EL MONTE UNION HIGH SCHOOL DISTRICT

April 26, 2023

TO : All Bidders
FROM : El Monte Union High School District
BID # : 2022-23(B8)
PROJECT : Mountain View HS Modernization Project
SUBJECT : Addendum No. 6

1. LPA Architects Addendum No. C issued April 26, 2023 attached.

PARKWAY DRIVE VEHICULAR ENTRY

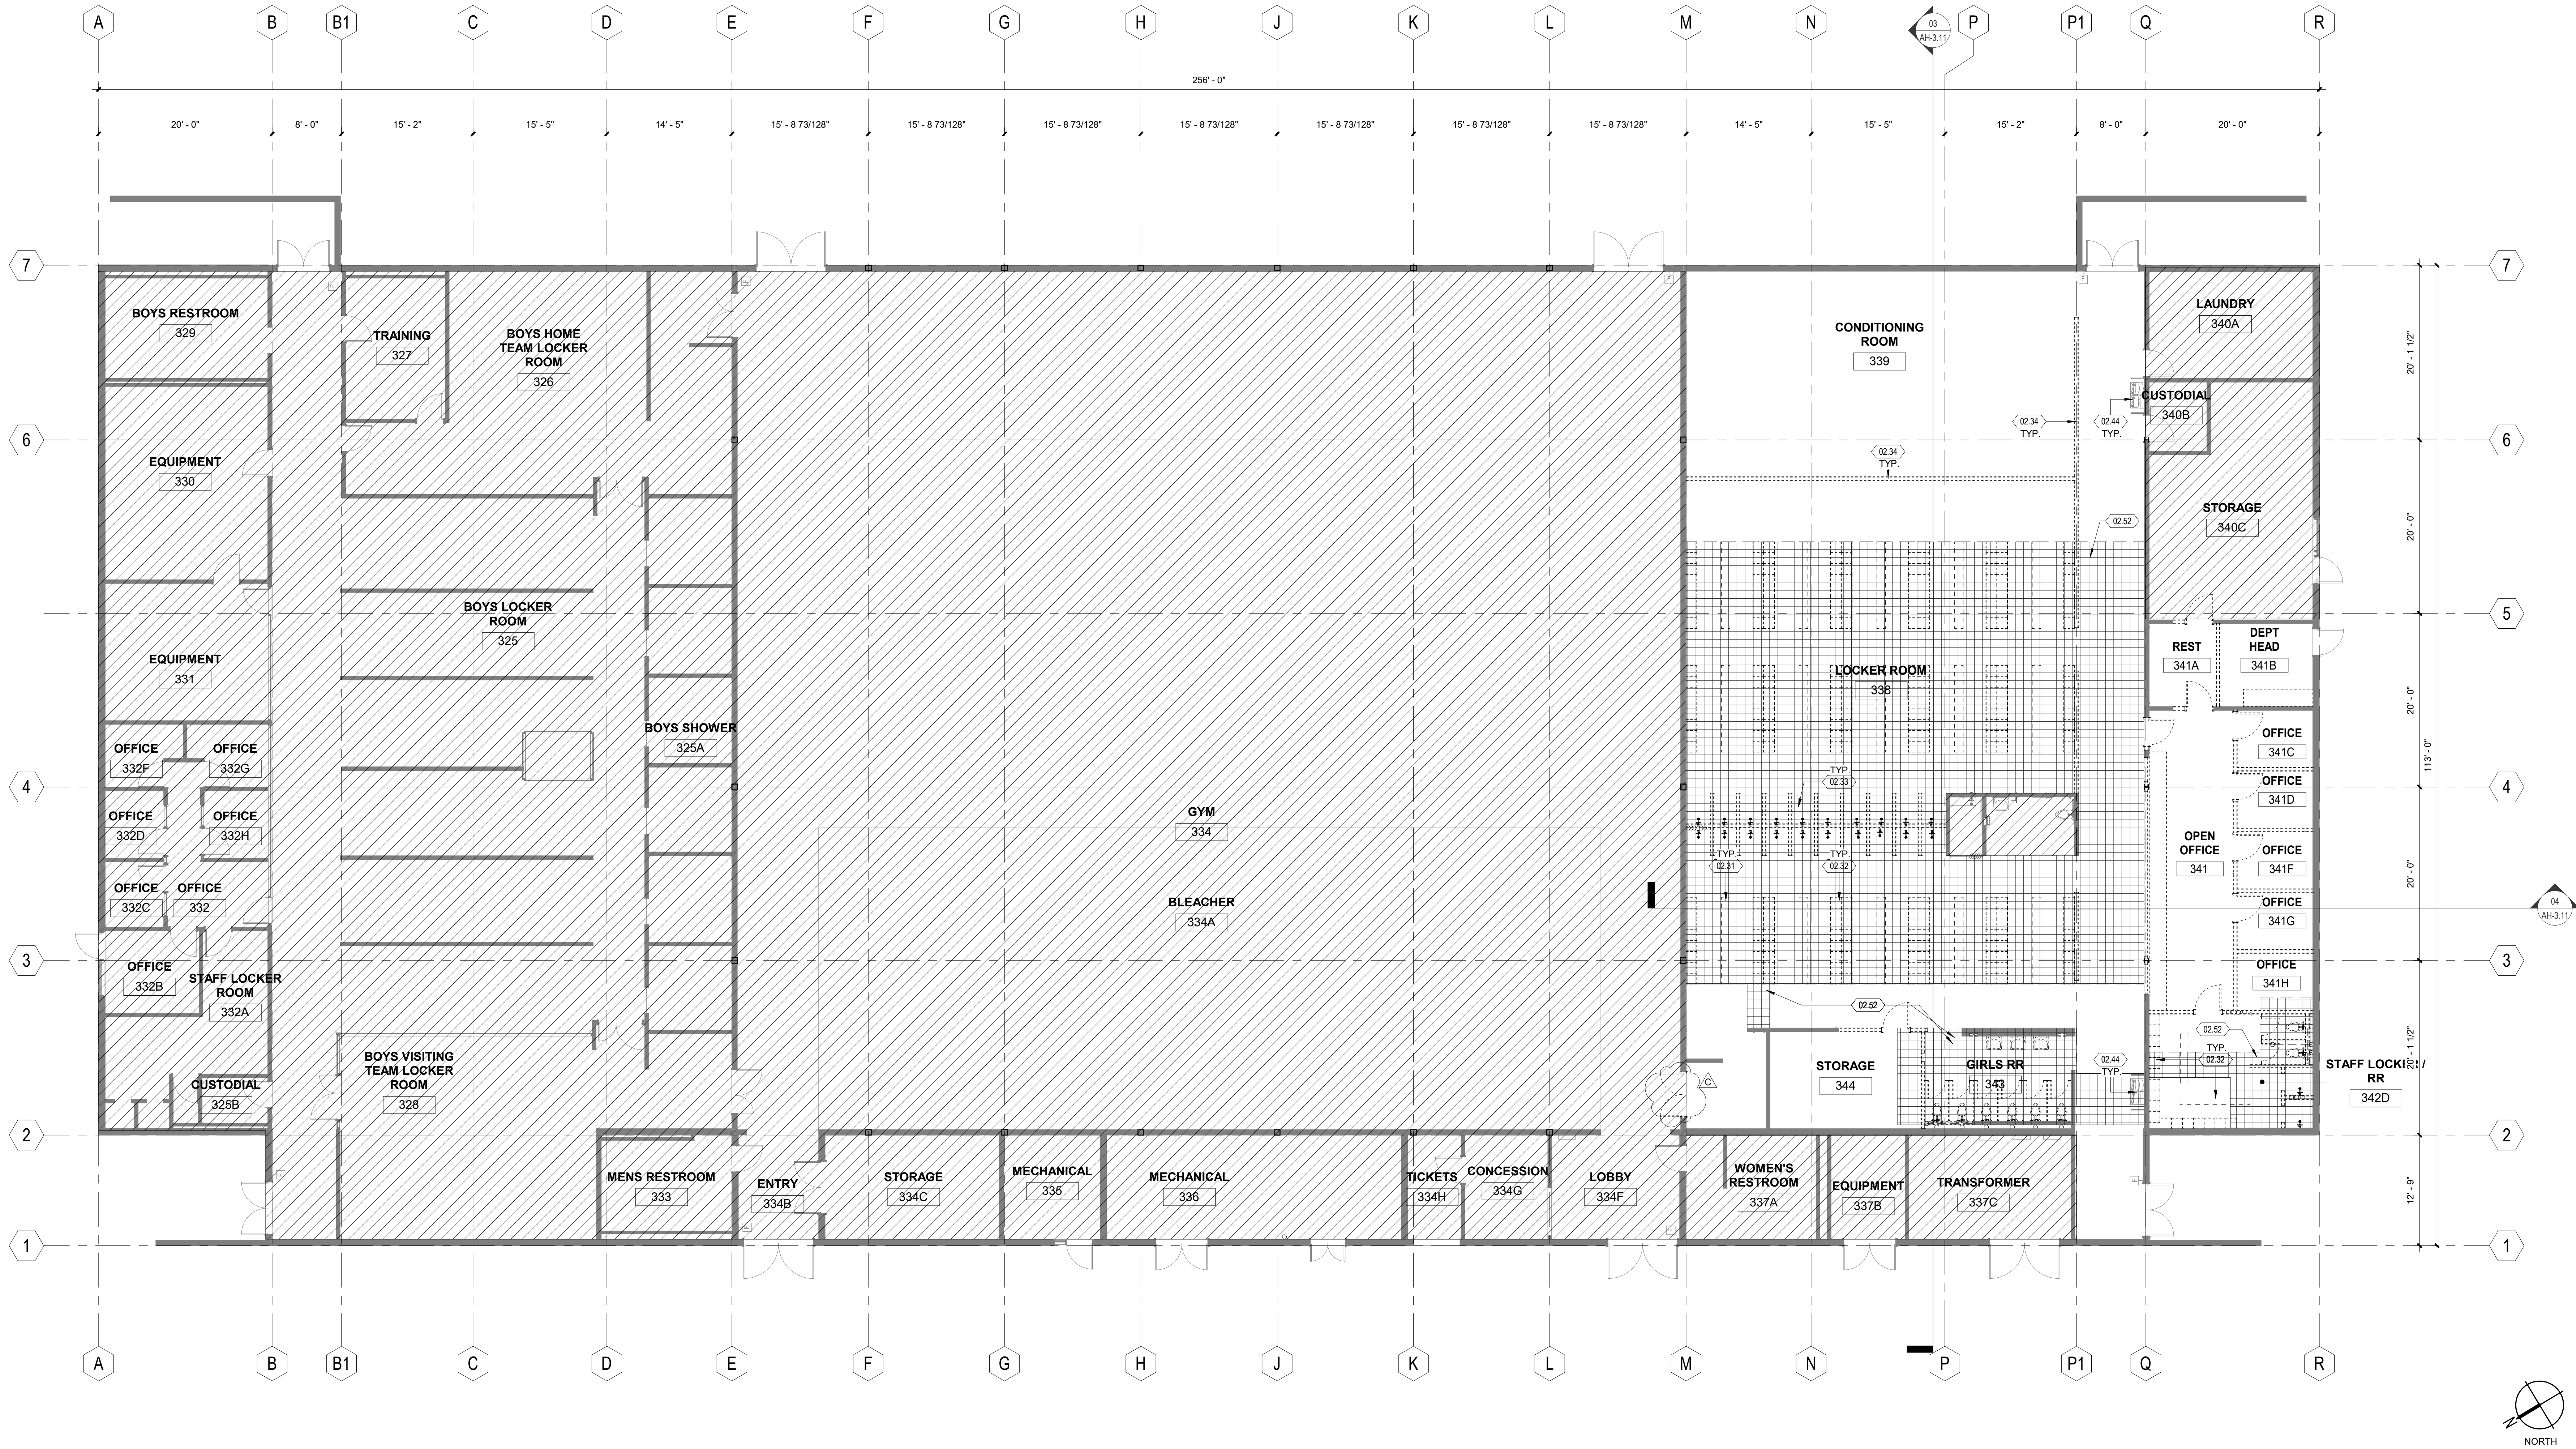
Item No. 14 **Sheet L3.01– Enlargement Plan**
(a) Clarification on gate/fence location on detail 05.

BUILDING H - RECONSTRUCTION FLOOR PLAN 1/8" = 1'-0" 02

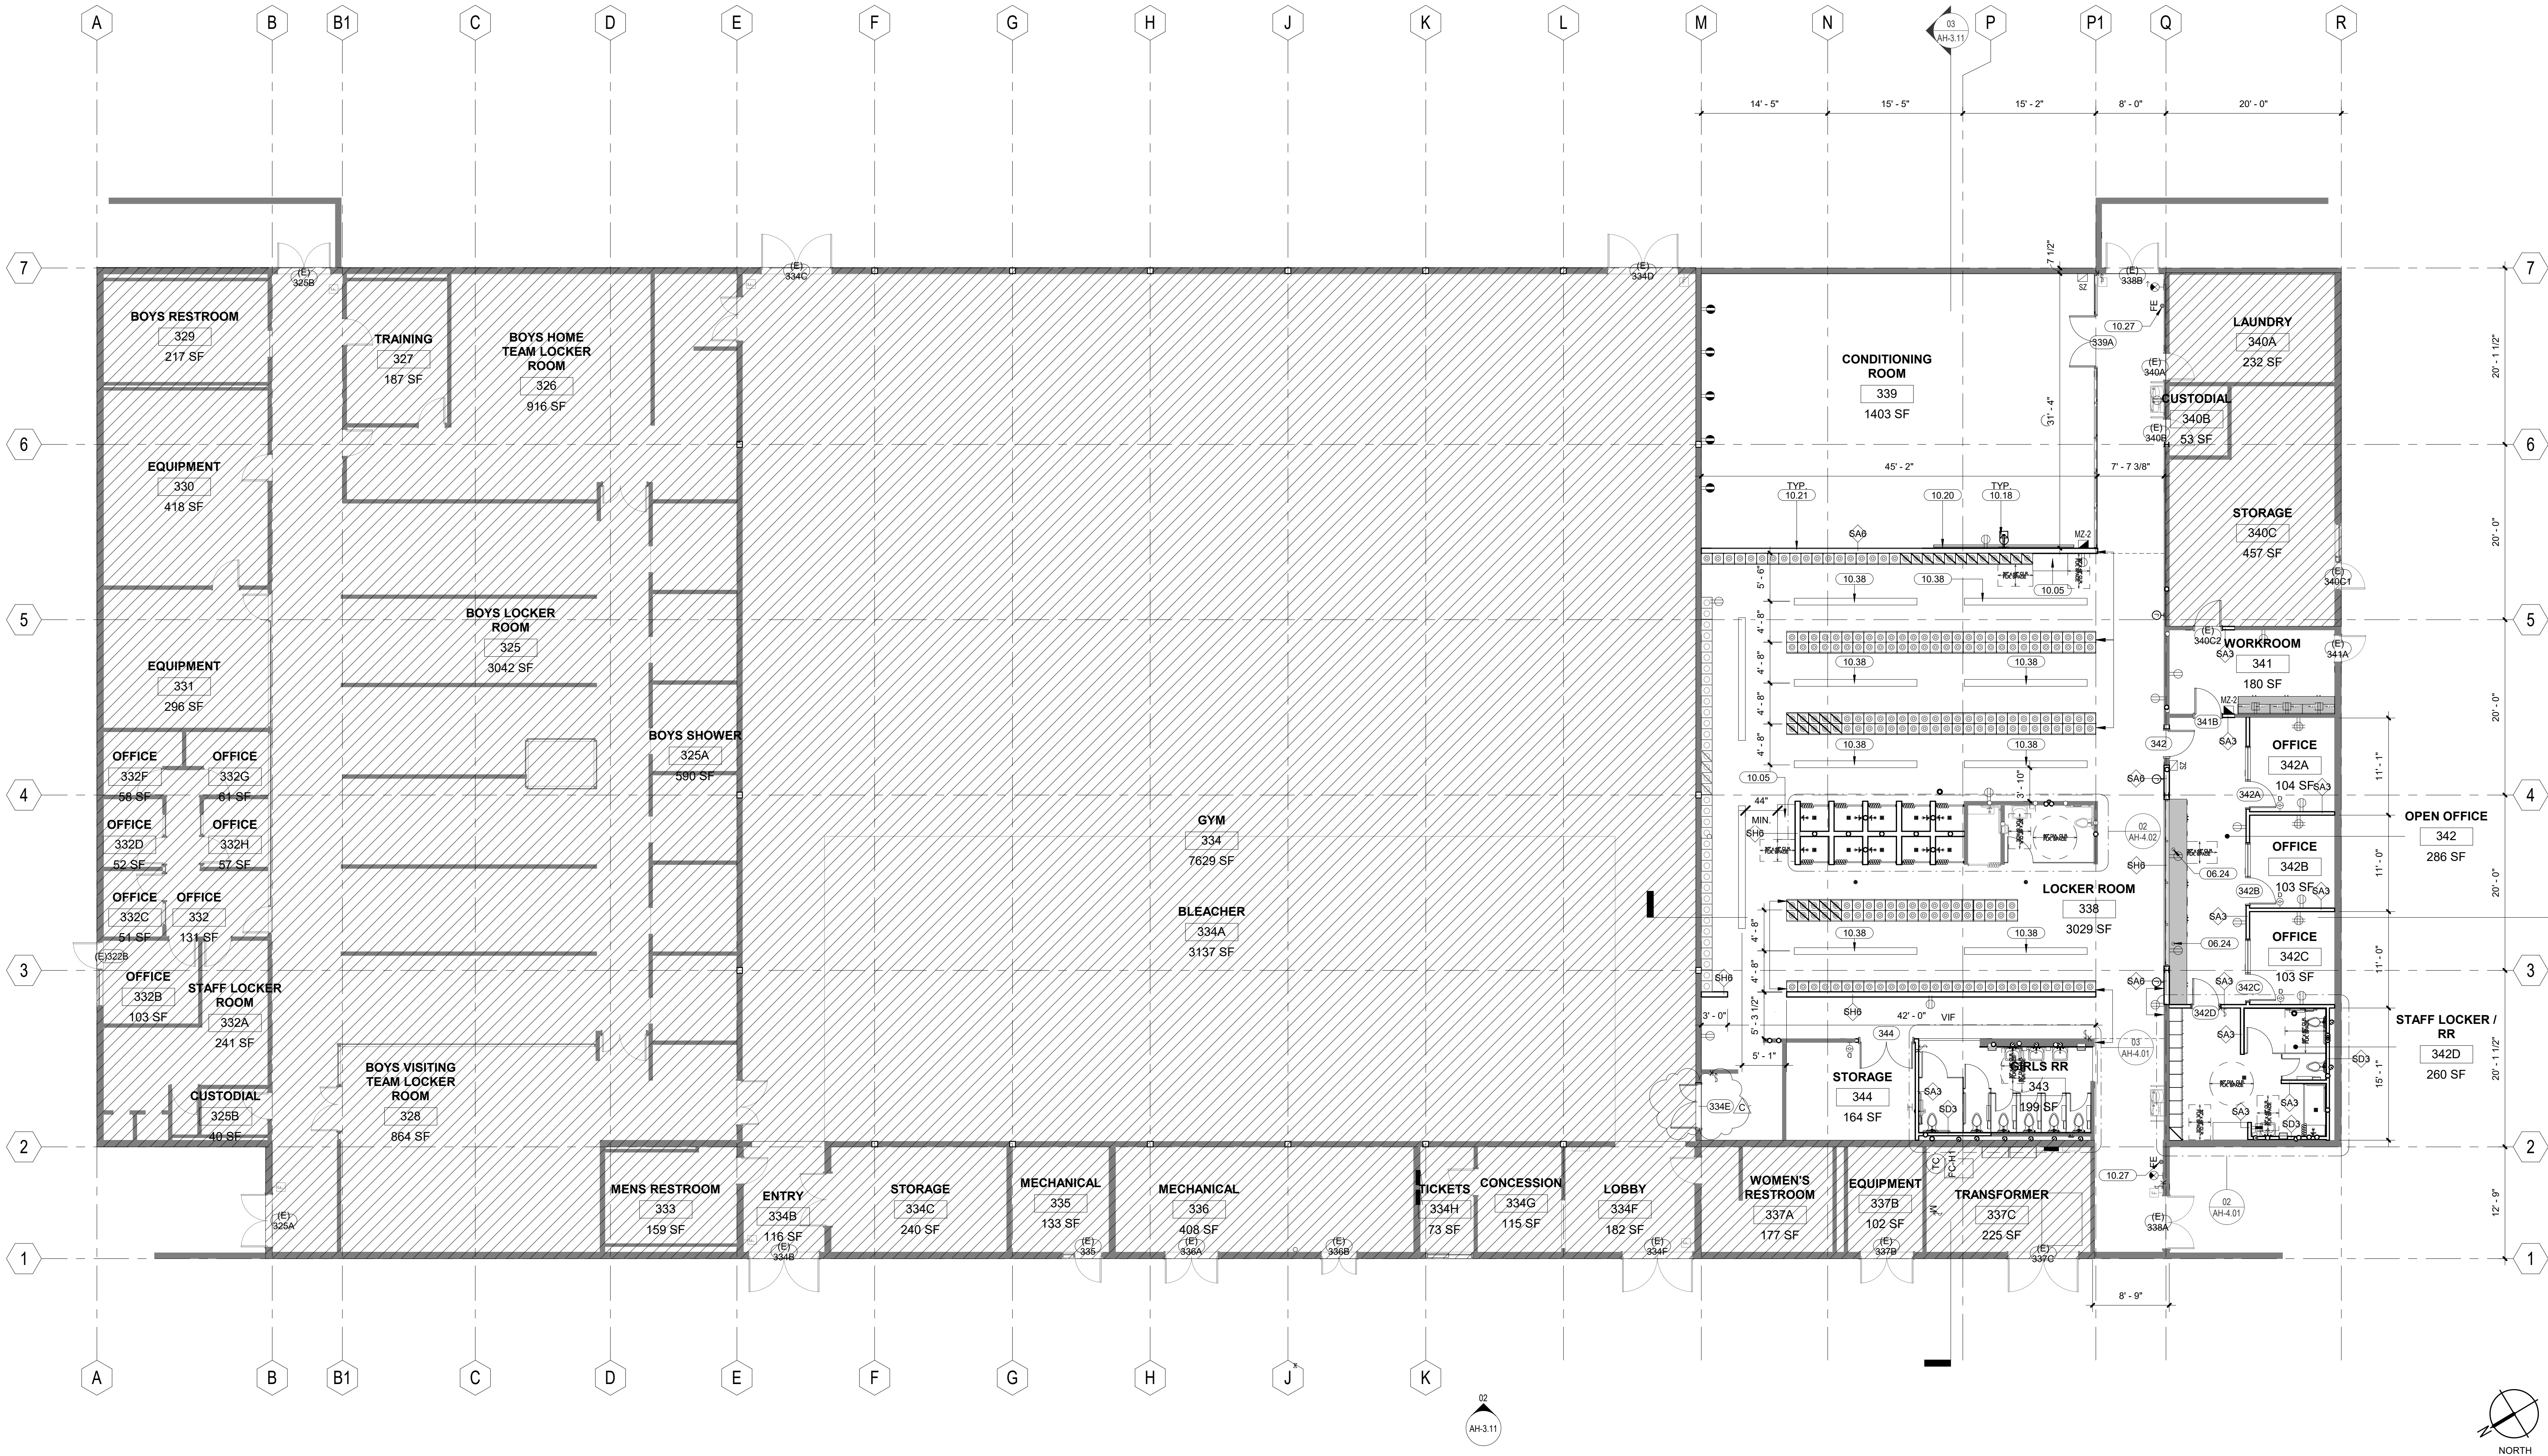
Item No. 17 **Sheet AH-2.11 – Reconstruction Floor Plan**
Provide new uneven door 334E.
